EDGEWATER REDEVELOPMENT

SUBMITTAL PACKAGE
URBAN DESIGN COMMISSION

SUBMITTED BY:
LANDMARK X, LLC
A WISCONSIN LIMITED LIABILITY COMPANY

DESIGN EVOLUTION – INTEGRATION OF UDC COMMENTS

PUBLIC SPACE

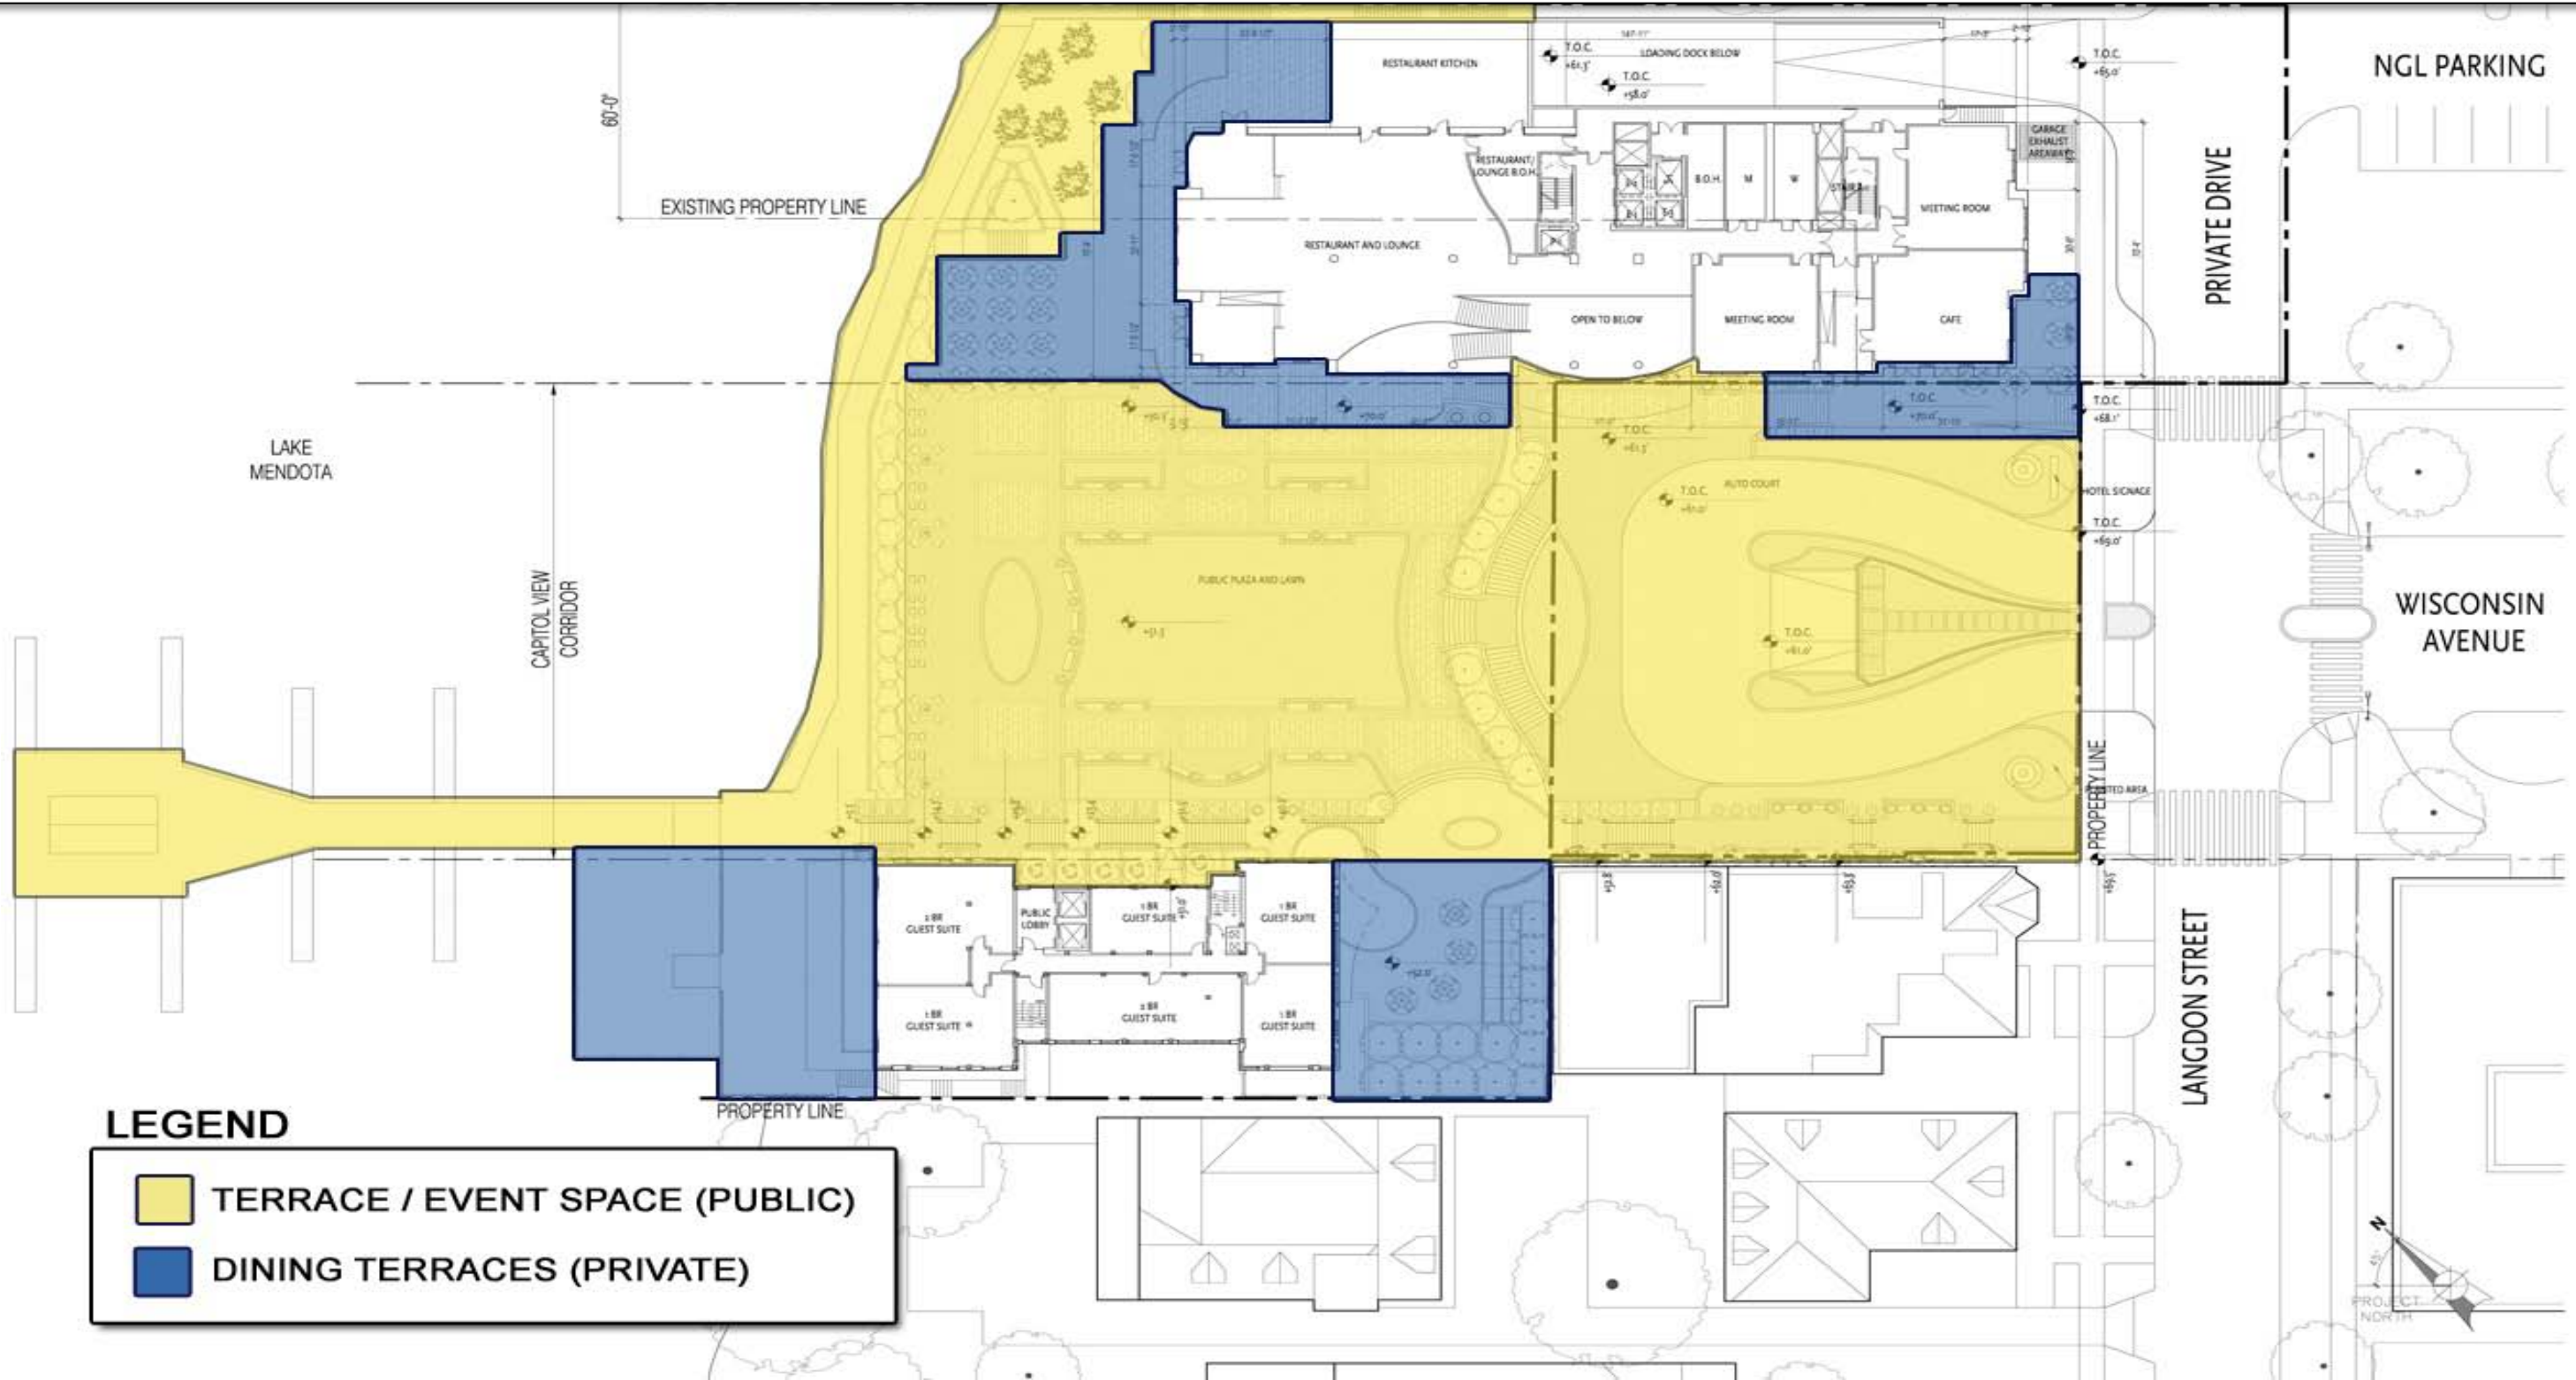
INFORMATION REQUEST: Explain how design of the public spaces has evolved to respond to comments from UDC and Others.

INFORMATION REQUEST: Clearly delineate public spaces including program and access information.

- » Re-oriented Pedestrian Areas in Auto-Court;
- » Separated of Cars & Pedestrians;
- » Lowered Cars out of View Corridor;
- » Relocated Trucks/Buses from Plaza;
- » Added to Public Space Fronting Water;
- » Reduced Dedicated Restaurant Terrace.

PUBLIC SPACE – GRAND STAIR

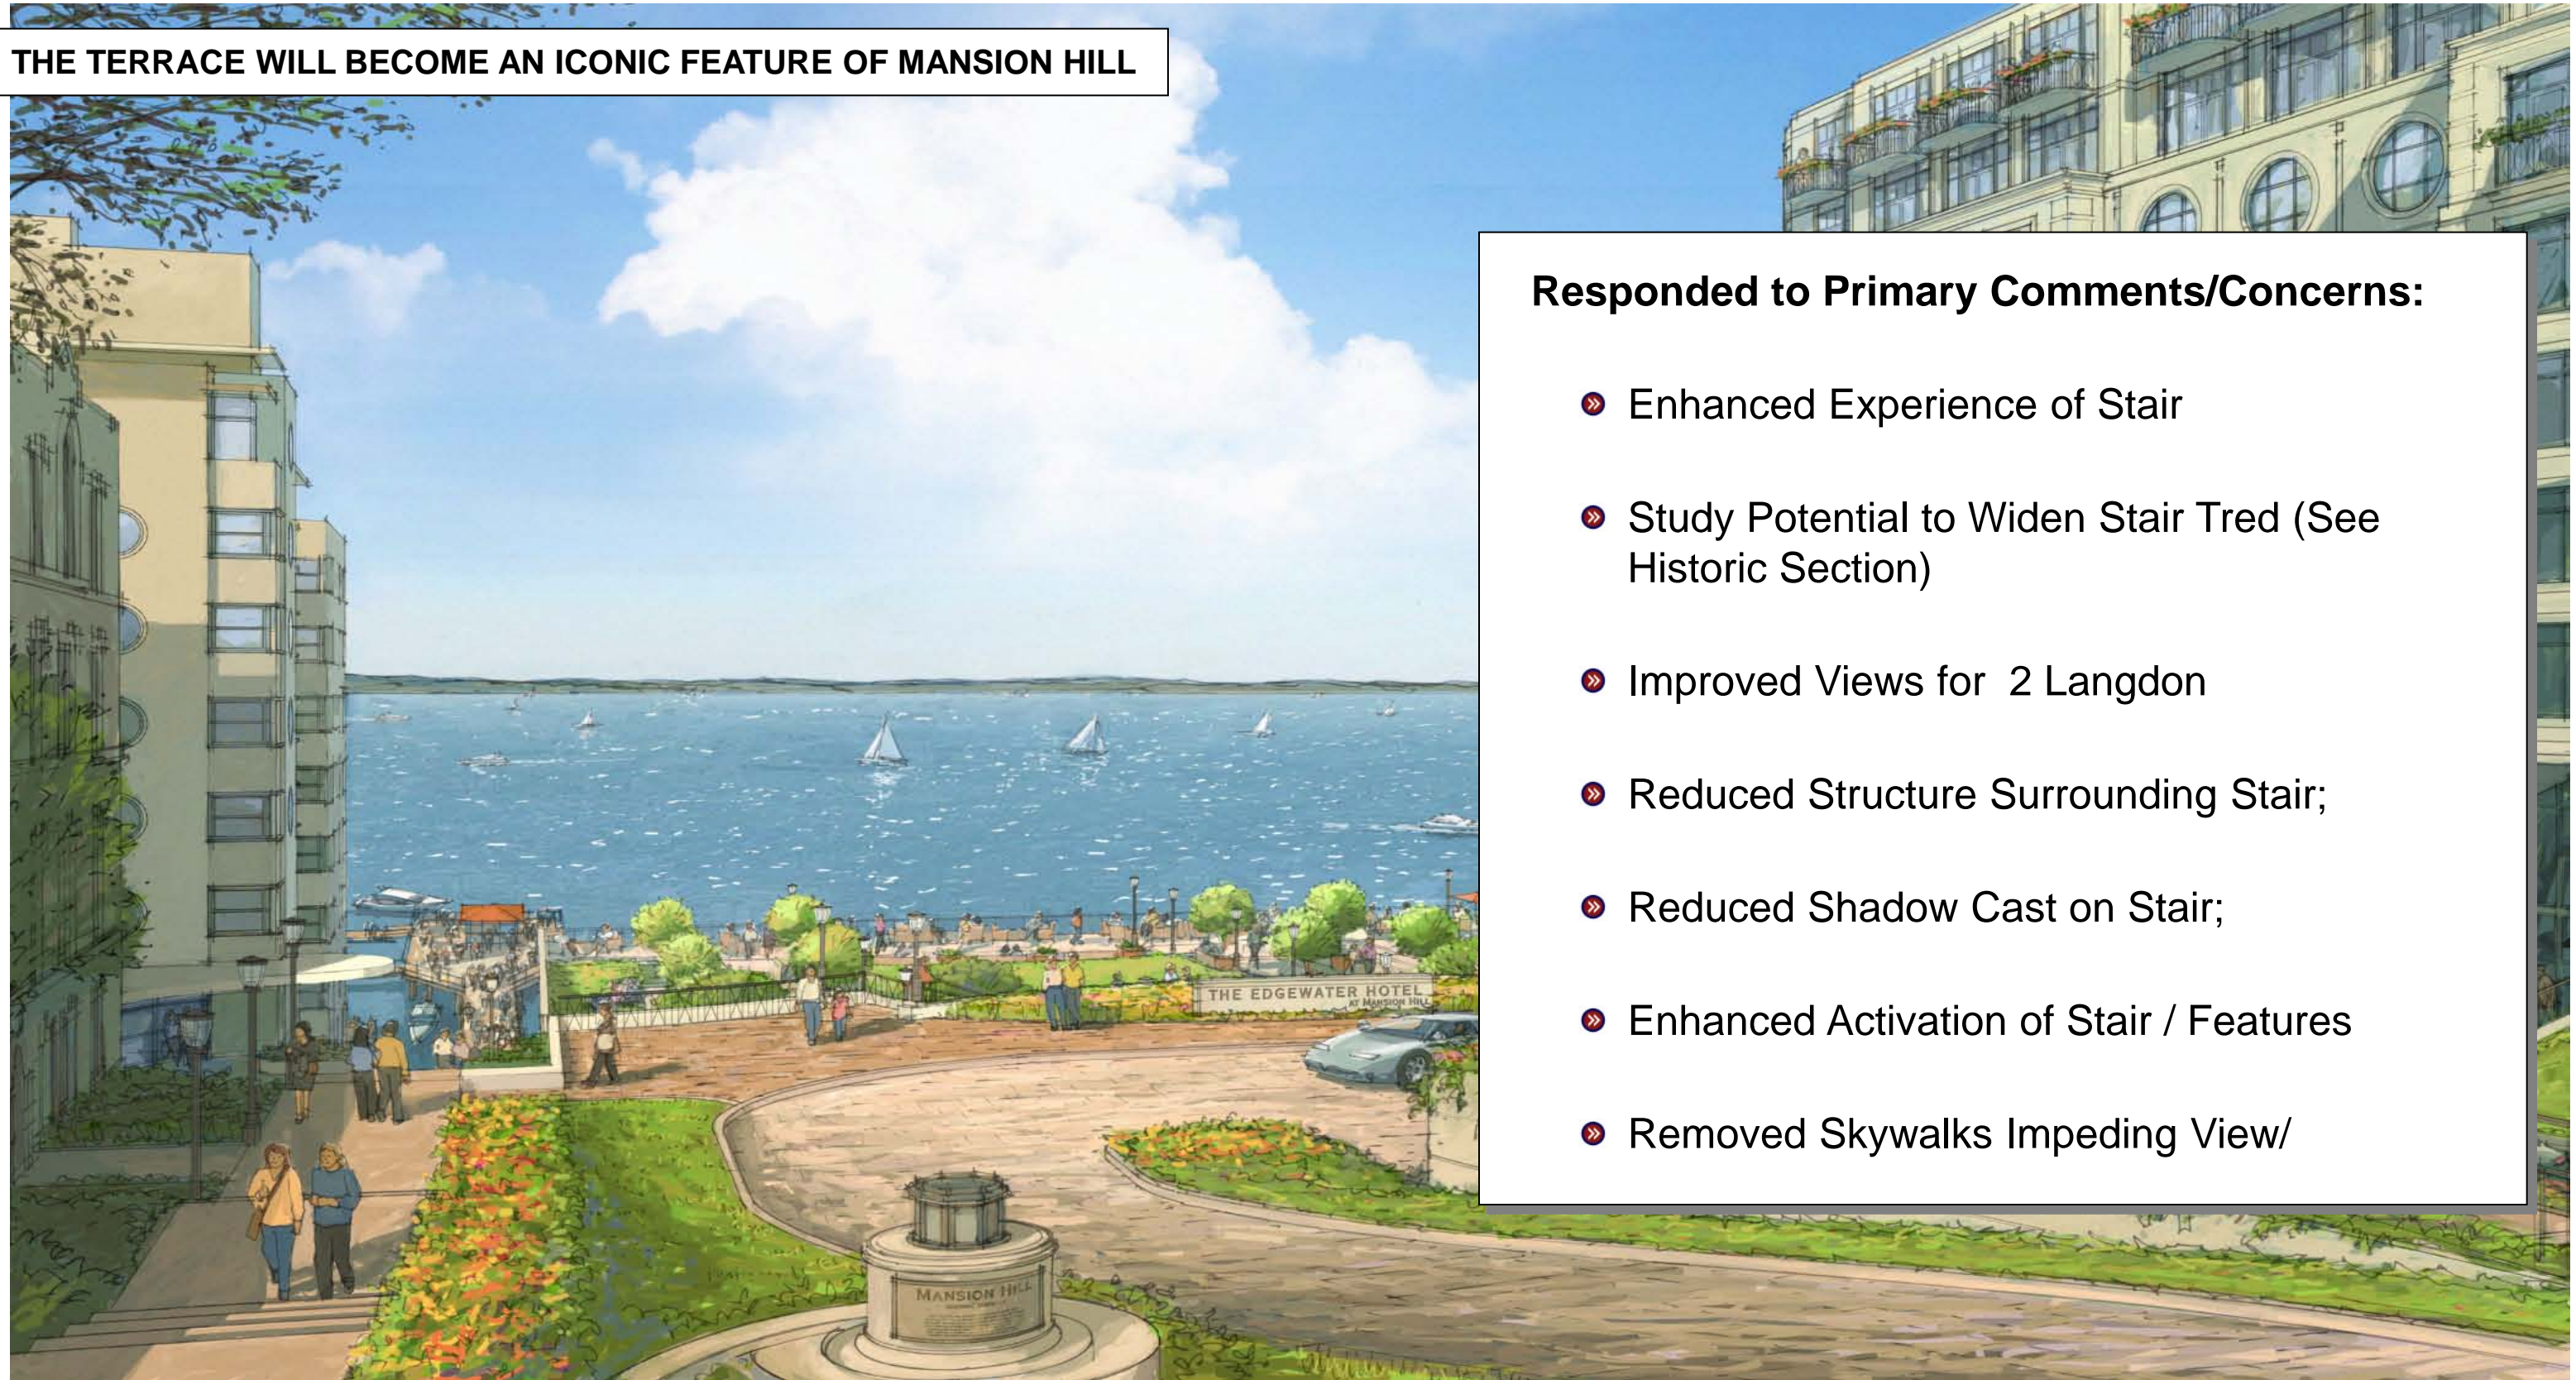
| <input checked="" type="checkbox"/> | Show Improvements to Public Space/Grand Stair | Section 7.0, Pages 17-19 |

MORE THAN 20 FEET OF STRUCTURE IS REMOVED FROM STAIR

TRAFFIC AND CIRCULATION – VEHICULAR MOVEMENTS

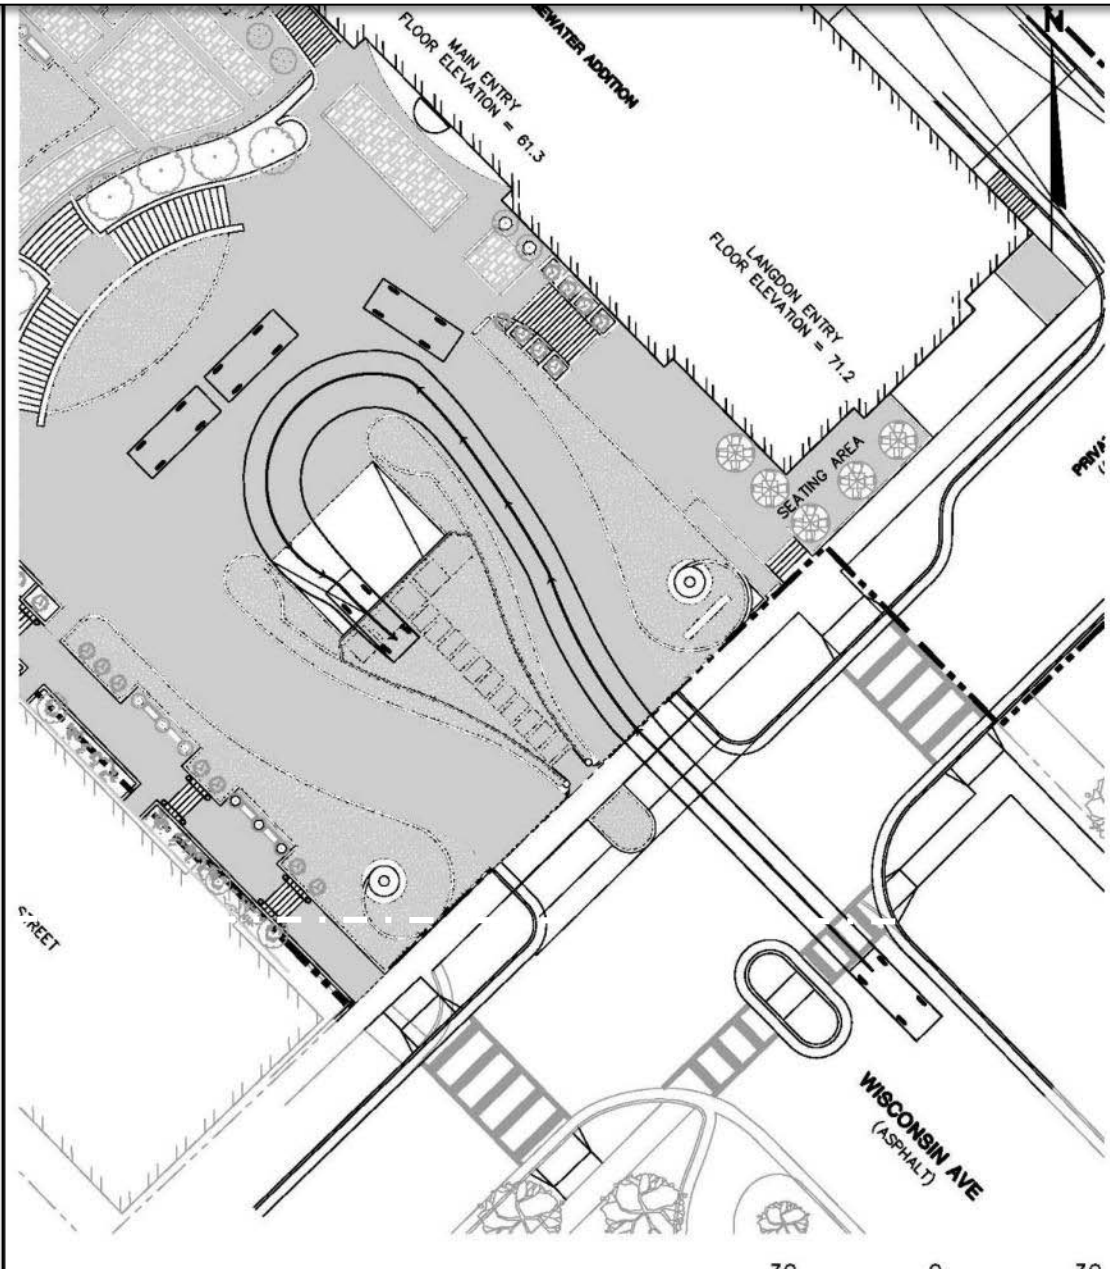
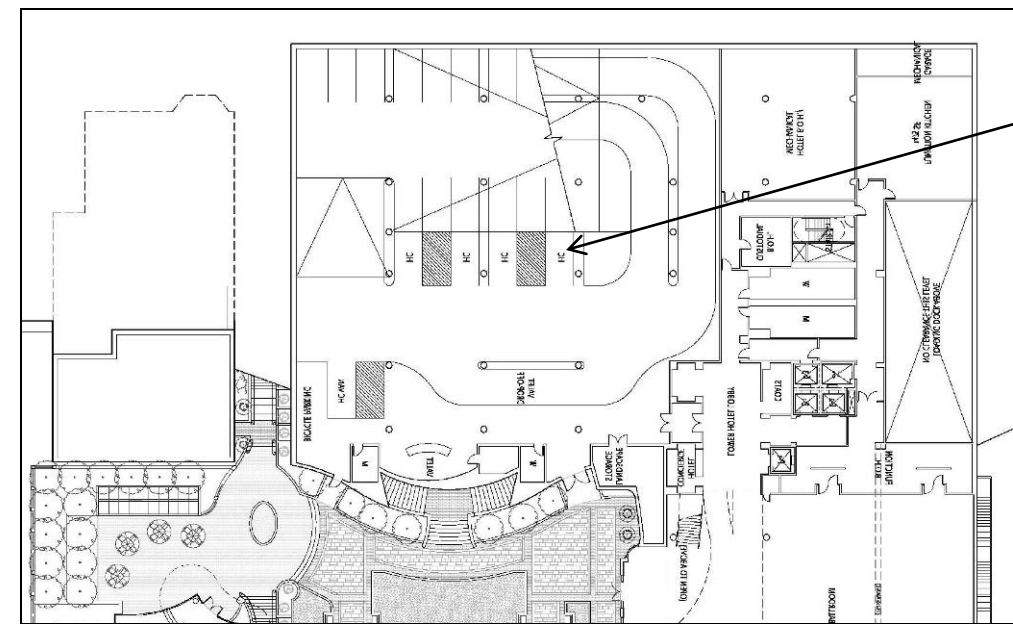
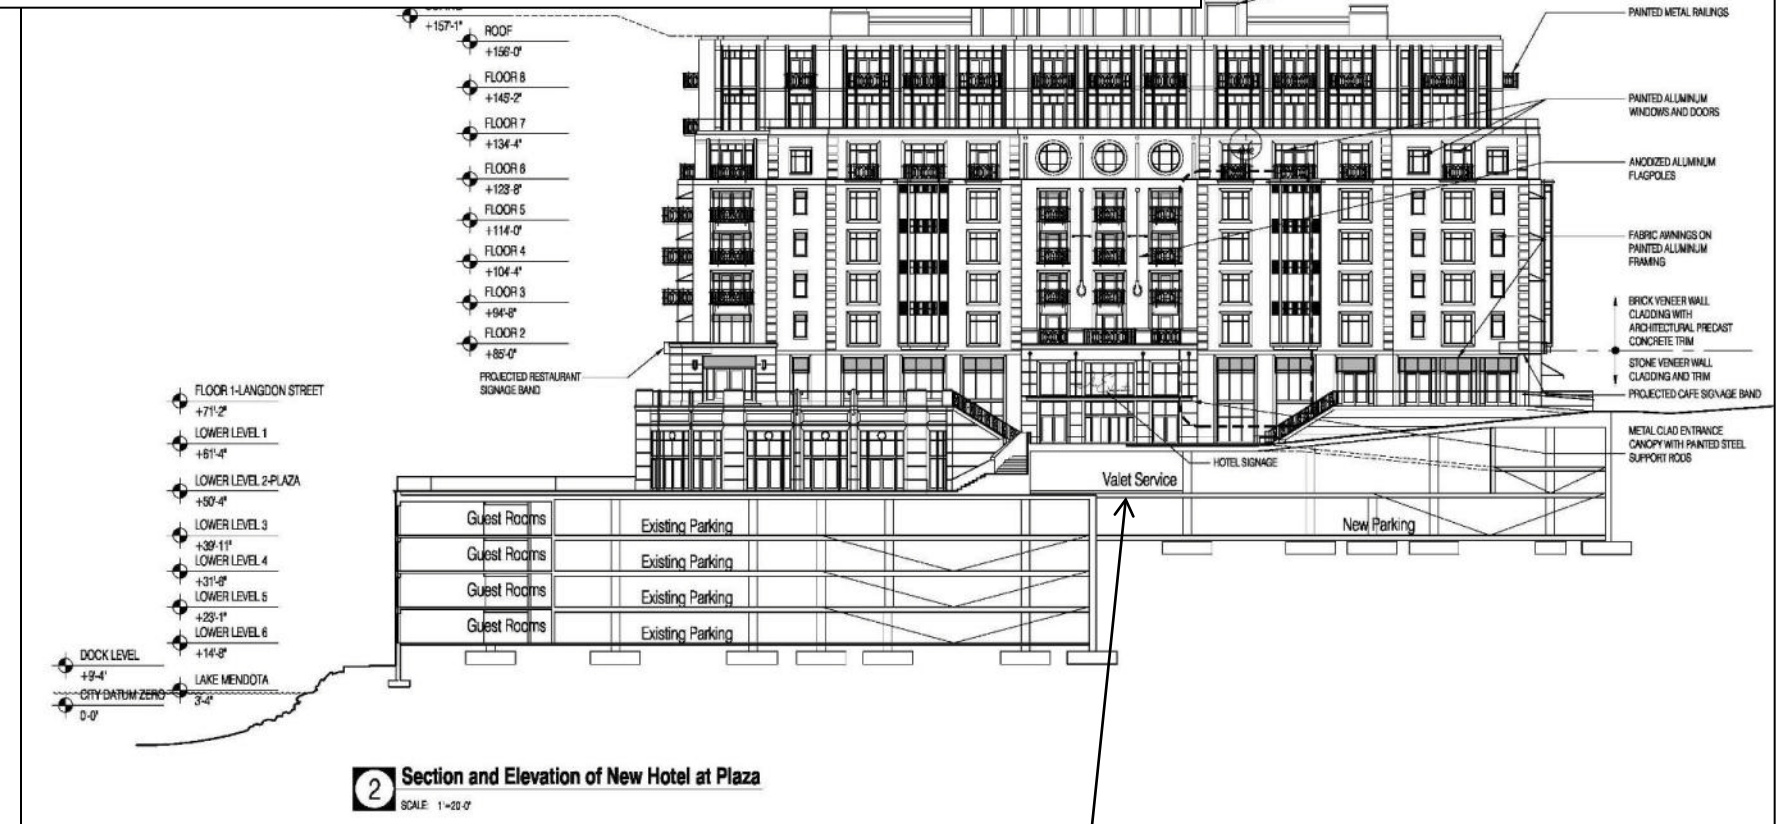
INFORMATION REQUEST: Describe vehicular movement on the site. Where do cars enter parking structure. Where is valet/drop off area.

INTERNAL VALET MITIGATES TRAFFIC IN VIEW CORRIDOR

The revised plan includes an internal valet and drop-off area to further mitigate traffic impacts in the view corridor, provide a direct drop-off for functions/events and provide an enhanced drop off for guests in inclement weather.
